# 1972 F7-A

## PARTS DIAGRAM

### SWING ARM/SHOCK ABSORBERS ('71-'73 F7/F7

| Ref. No. 27, Chain Adjuster |                                               |                       |

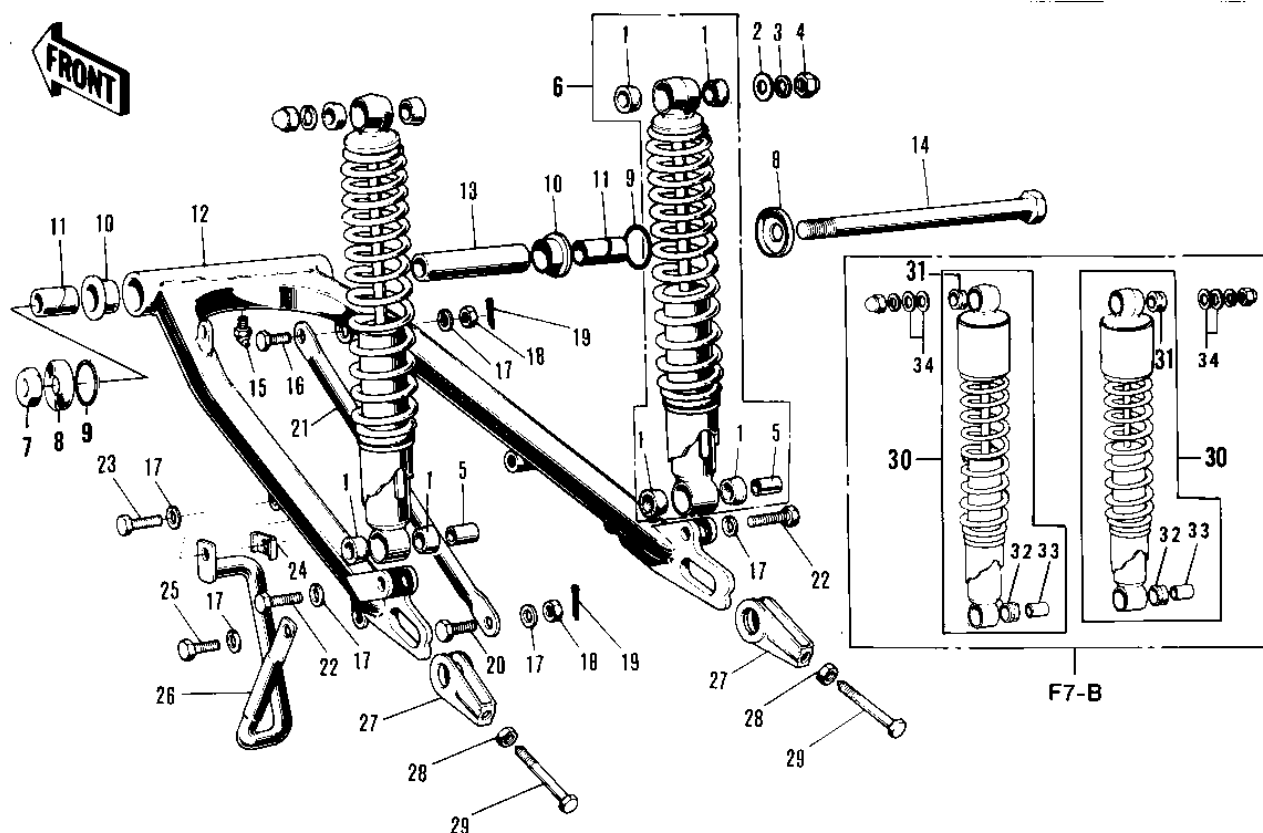
| Ref. No. 27, Chain Adjuster |                                               |                       |
|-----------------------------|-----------------------------------------------|-----------------------|
|                             | OLD                                           | NEW                   |
|                             | 1.6 mm<br>15.2 mm<br>                         | 3.2 mm<br>13.7 mm<br> |
| Chain Adjuster              | 33041-041                                     | 33041-048             |
| Collar                      | 42032-027                                     | 42032-036             |
| Frame No.                   | ~20779                                        | 20780~                |

| Ref. No. 27, Chain Adjuster |                                               |                       |
|-----------------------------|-----------------------------------------------|-----------------------|
| Interchange?                | Use new parts as a set in place of old parts. |                       |
